Fresenius Medical Care North America Service Bulletin

Equipment: All 2008® Series Hemodialysis Machines
 Bulletin: 22-FRS-002 Rev A
 Subject: Power Supply Heater Cable Wire Connections

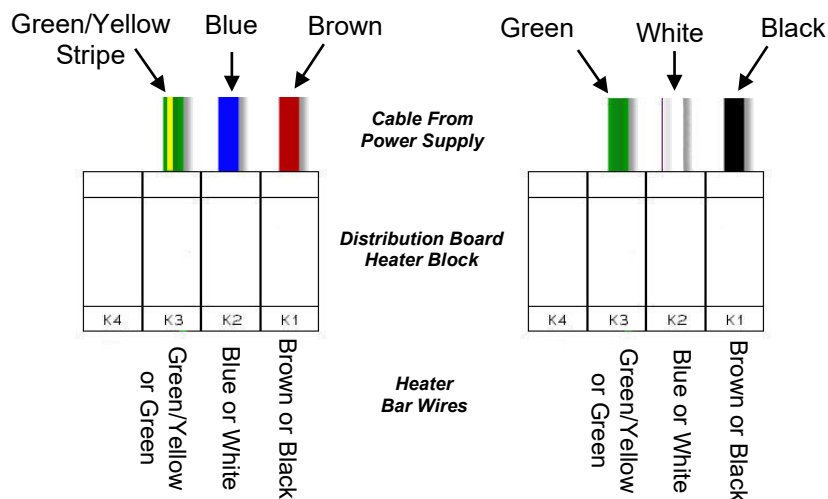
- Examine each wire and remove any stray wires not captured by the ferrule.
- Insert the wire/ferrule into the Distribution Board Heater Block just far enough so no insulation will be crimp when the screw is tightened.
- Before tightening each screw verify again that there are no stray wire strands.
- Securely tighten each screw.

When replacing the power supply heater cable use the illustrations below to assist in correct wire color placement.
